CITY OF ALBUQUERQUE

**RE: Garcia Honda Gen 3 Service Bldg
8301 Lomas NE
Grading and Drainage Plan
Engineer's Stamp Date 8/29/17 (File: J19D072)**

GARCIA HONDA - GENERATION 3 - NEW SERVICE BUILDING

Mark	Date	Description
	05/05/17	Date
	15918	Project Number
	JUB	Drawn By
		Checked By
		Copyright ©
		PC
		VAN H. GILBERT ARCHITECT
		SHEET TITLE
		GRADING, DRAINAGE & UTILITY SERVICE PLAN
		C-101
		OF

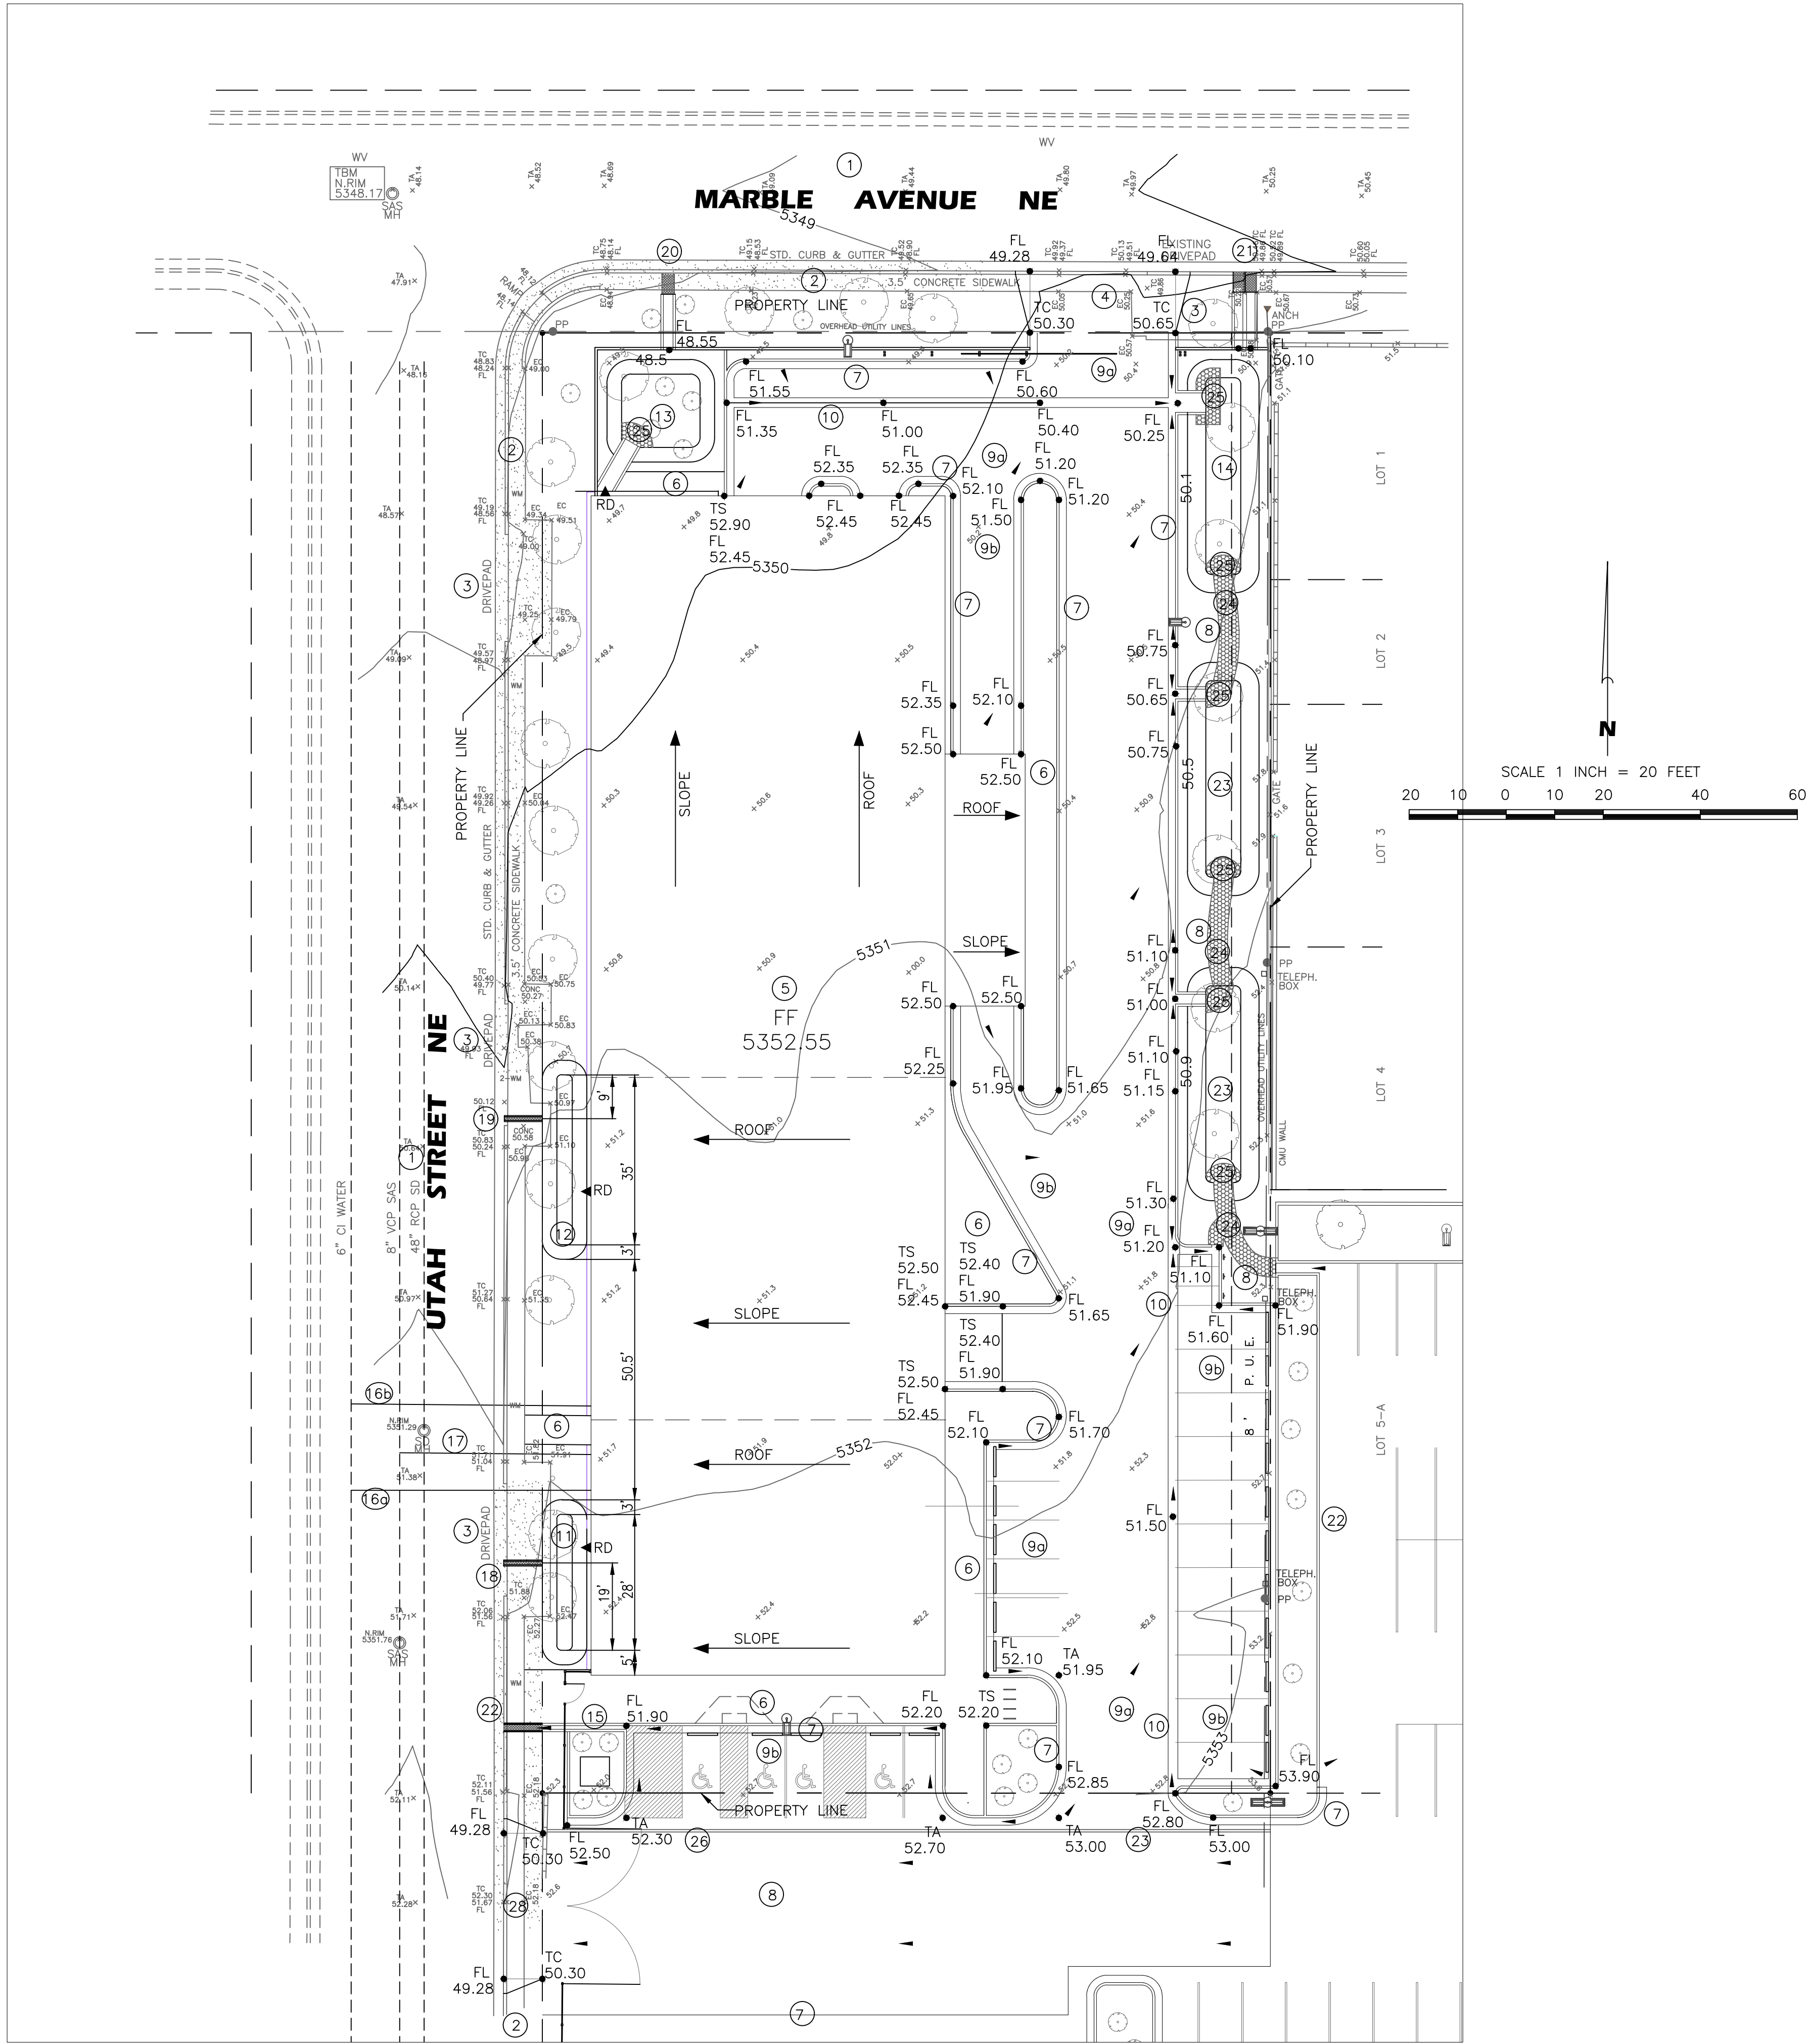
Based on the information provided in your submittal received 8/30/17, the Grading and Drainage Plan are approved for Building Permit. However, prior to Hydrology Final Inspection for Certificate of Occupancy the following condition must be met:

1. A Bernalillo County Recorded Private Facility Drainage Covenant is required for the ponds. Please contact Charlotte LaBadie (clabadie@cabq.gov, 924-3996) or Madeline Carruthers (mtafoya@cabq.gov, 924-3997) regarding the routing and recording process for covenants.
